Source: Prestolite Leece-Neville Heavy Duty Systems
Bulletin No: TSB-1240 **Date:** January 30, 2024
Models: MDA3946 MDA3946-1
Subject: Terminal identification to AVI143J3004E

This document will help identify terminal location variances.

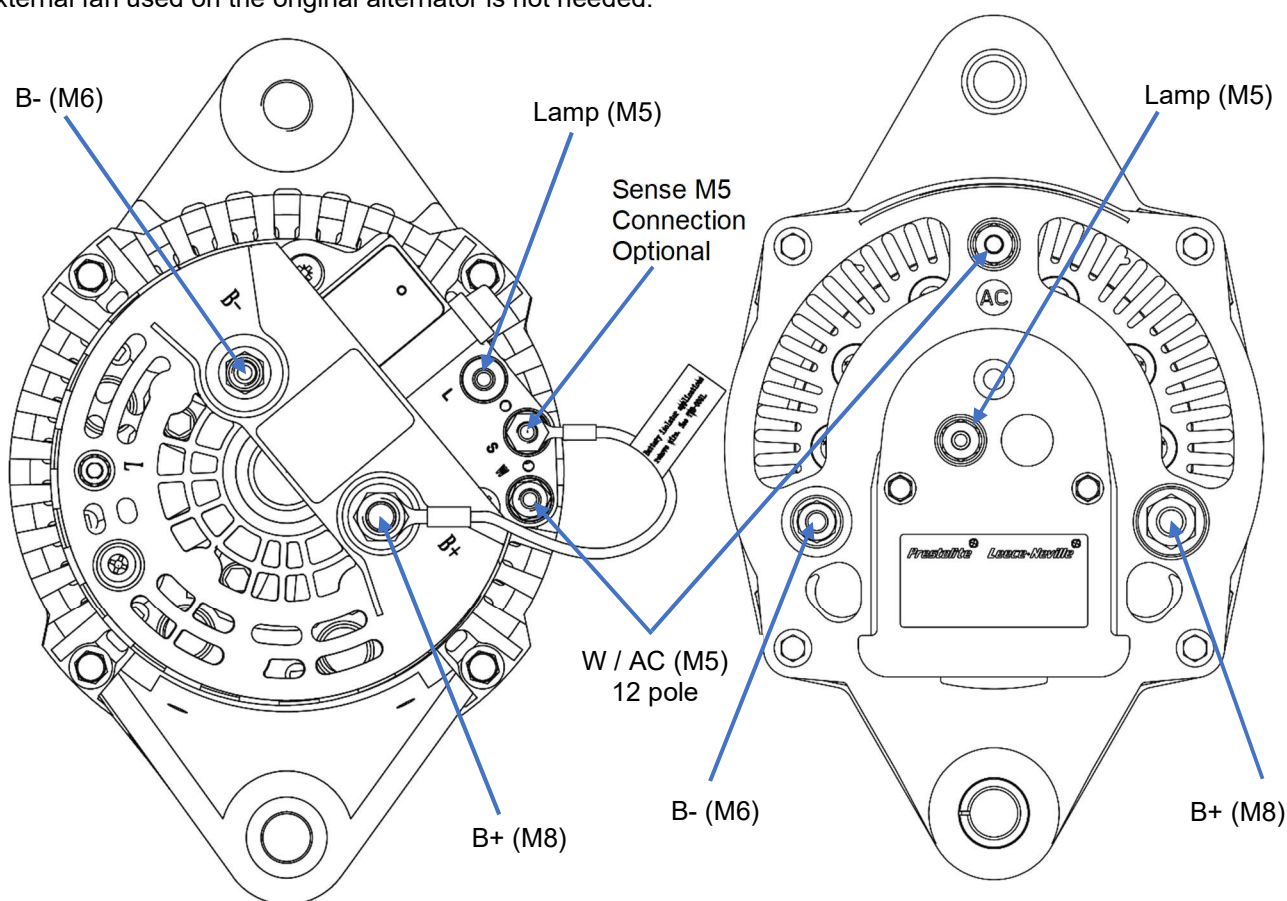
Both original and replacement AVI143 are self-excite alternators.
Both alternators are isolated ground.
See TWB-0091 to wire AVI143J3004E alternator.

! AVI143J3004E has internal cooling fans.
External fan used on the original alternator is not needed.
